## **MCDONNELL DOUGLAS**

July 25, 1990  
C1-AF1-TMR-069

Douglas Aircraft Company (DAC) has reviewed the draft of FAA/Joint Industry Noise Abatement discussion paper which was distributed during the June 19, 1990, meeting. We wish to offer the following comments:

Fokker comments on Joint FAA/Industry noise abatement discussion paper.

#### MODE 3 - Altitude Loss After Takeoff

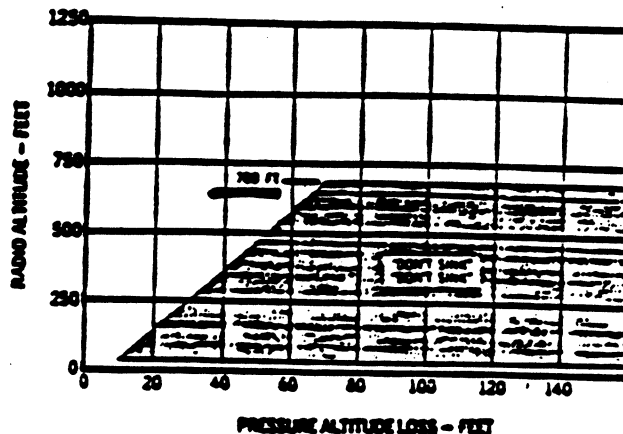
Both the MARK II and MARK V systems provide several ARINC defined modes of operation including Mode 3, ALTITUDE LOSS AFTER TAKEOFF. Mode 3 will be the mode of interest during takeoff noise abatement thrust cutbacks.

GPWS Mode 3 provides a warning during takeoff in event of barometric altitude loss exceeding approximately 10% of the radio altitude where the initial descent began. Mode 3 is inhibited above 700 ft. AGL in the MARK II system and inhibited above 2500 ft. AGL in the MARK V system.

**FIG. 1**

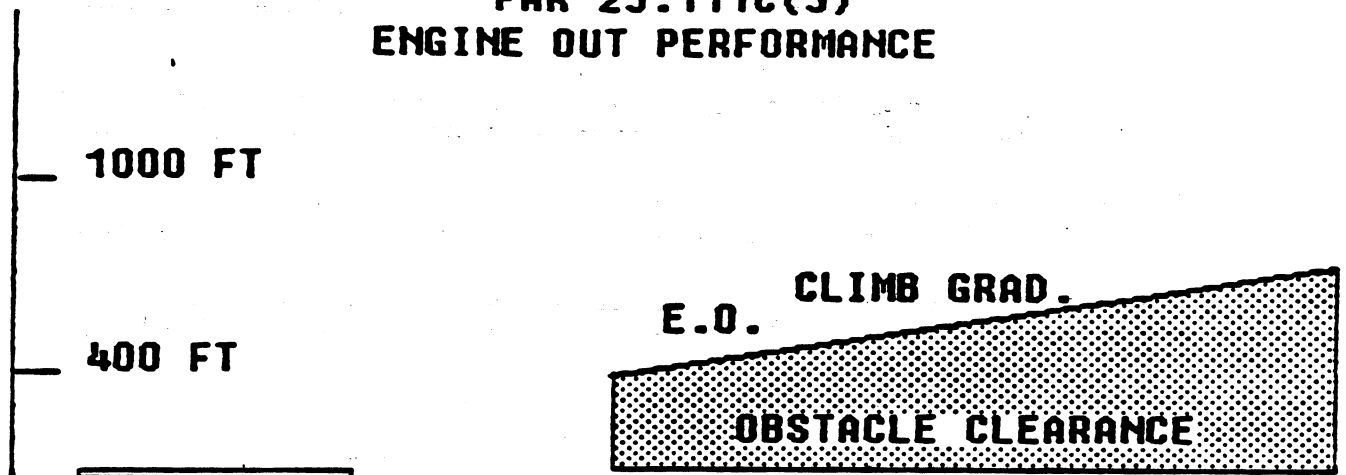
*The requirement for a thrust recovery system should be a function only of the magnitude of the thrust cutback.*

*FAR 25.111c(3) specifies an engine out gradient starting at 400 ft. that provides an obstacle clearance path. (See Fig. (1)). Any close-in noise abatement takeoff with a cutback initiated above 400 ft. and the appropriate thrust restoration method can*

(2) Any procedure which specifies a cutback thrust of less than that necessary to maintain FAR 25.111C(3) gradients would have to incorporate an automatic thrust recovery system. In no case shall the thrust be cut back to less than 0% all engines. I

**FIG. 2**

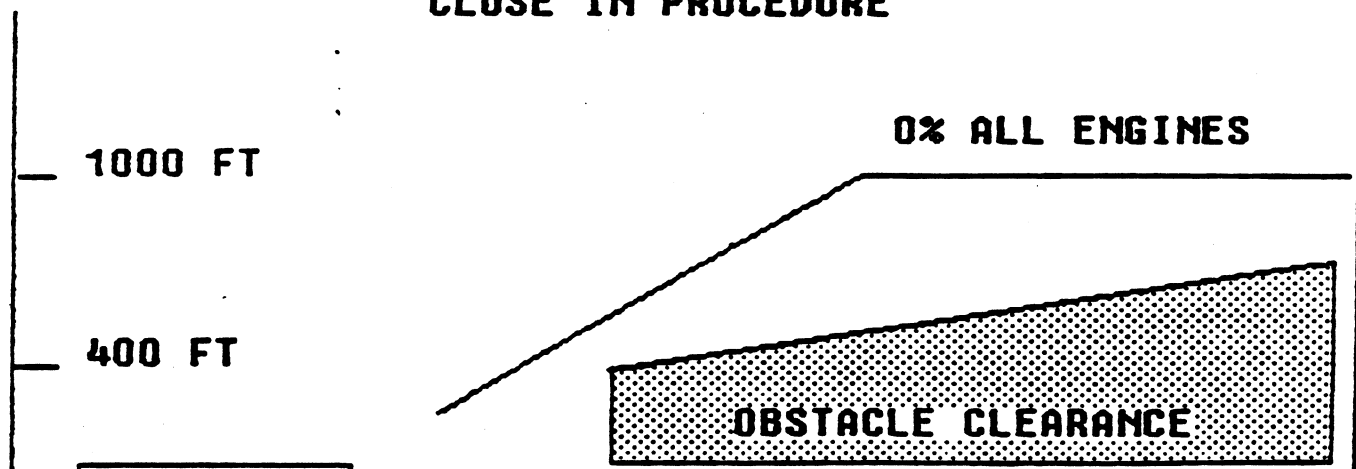
*maintain the aircraft at or above the FAR 25.111C(3) obstacle clearance path. (See Fig. (2)).*
